## DECISION OF 3793rd COUNCIL MEETING HELD ON MONDAY 27 NOVEMBER 2023

### 10.10 Planning Proposal 2/23 - 601 Pacific Highway St Leonards

## 10.10.Planning Proposal 2/23 - 601 Pacific Highway St Leonards

# PLANNING PROPOSAL (AMENDED)

**FIGURE 1:** Original section plan (Applicant's Urban Design Report, p.80).

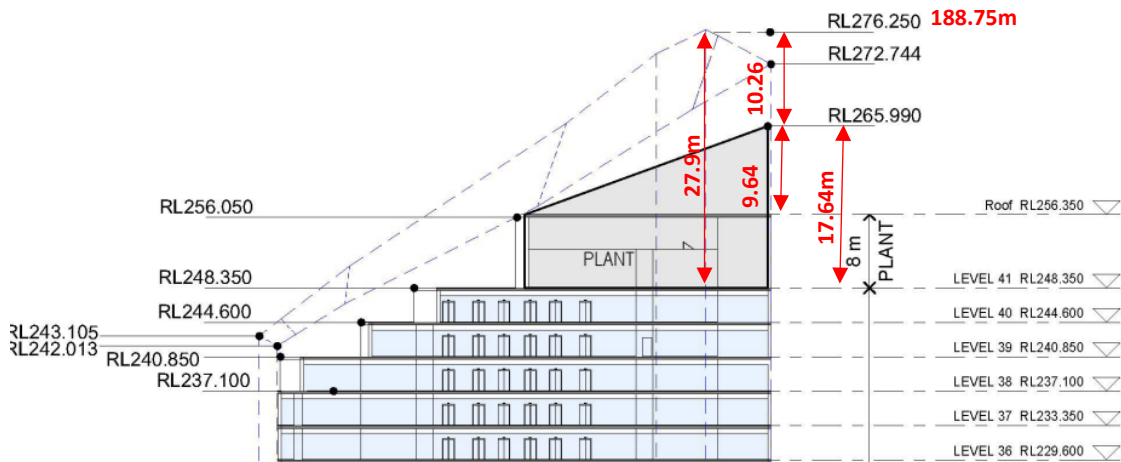
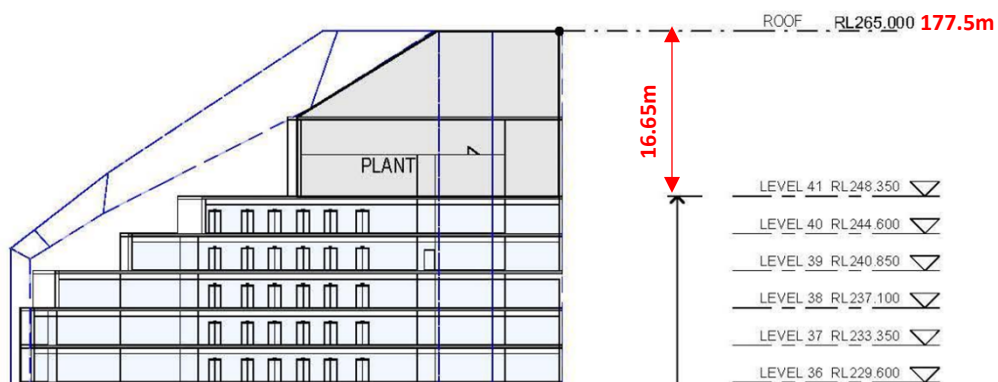
A comparison of the original and amended reference designs is shown in Figures 1 and 2 below.

The amended scheme has removed the additional allowance of 10.26m previously sought for the purposes of an architectural roof feature. Whilst the height of the top-level plantroom appears unchanged (at 8m), the clearance sought above the top-level plantroom has been reduced by approximately 1m (9.64m to 8.65m).

The applicant's justification for the proposed height of RL265 is that it *provides sufficient flexibility in the future detailed design, structural, and engineering arrangements for plant services (and the need to avoid a future building height variation)* and that 'Council's recommended height of RL259 does not provide sufficient scope for future servicing, in terms of accommodating volume and area for plant room heights, lift overruns, ventilation plants, cooling towers and water tanks.

It is considered that a maximum building height of RL259 is consistent with the 2036 Plan and other anticipated heights of buildings within the immediate context. Whilst the difference in the applicant's proposed height of RL265 and the recommended height of RL259 is 6m, this would result in shadow lengths approximately 18-20m longer than is necessary.

*The Panel considers that the plant room can be adequately accommodated within the maximum overall height limit of RL259 (equivalent to 171 metres), noting that this could require a reduction in gross floor area, and a reduction in the height of the architectural roof element.*

## 1.4 Indicative Sections

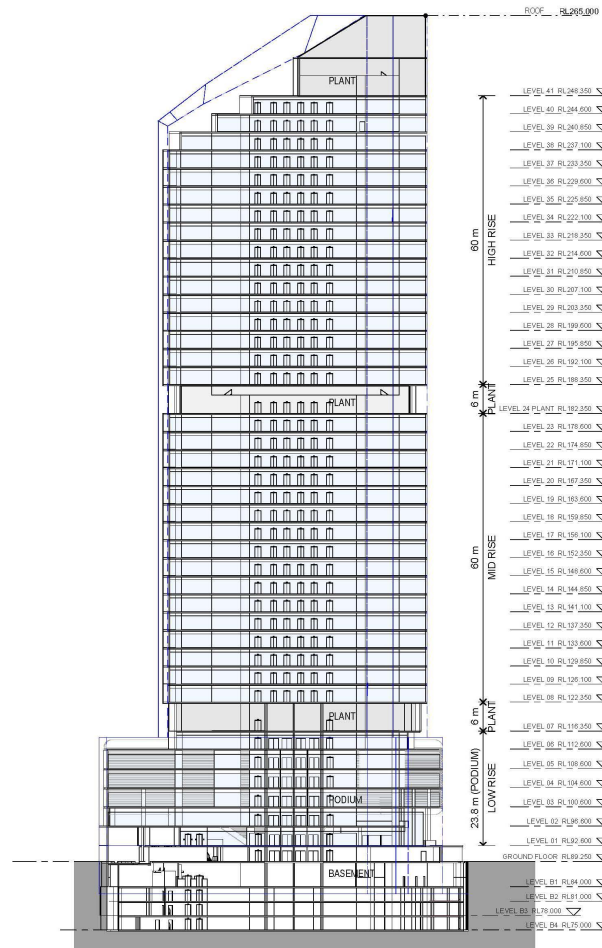
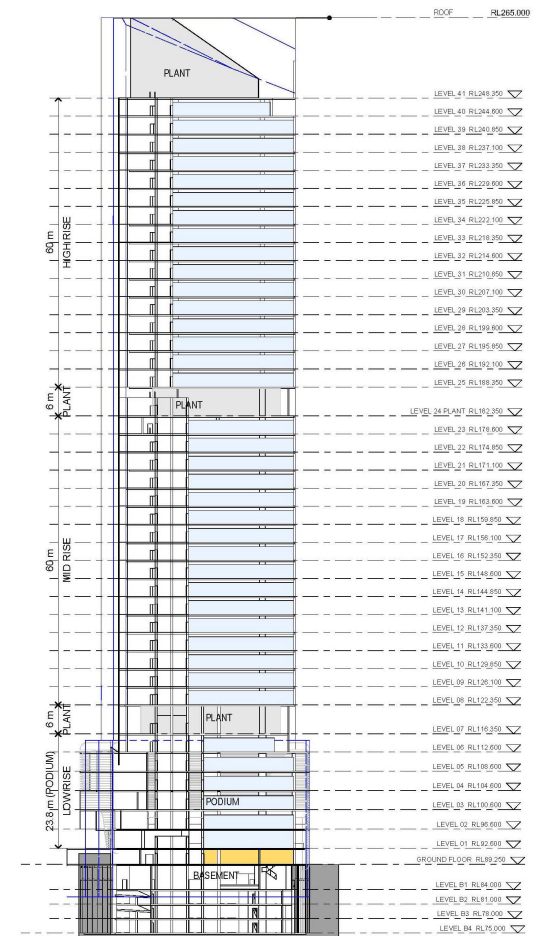
Building envelope height has been updated to RL265m, and architectural form of the roof top has been adjusted accordingly
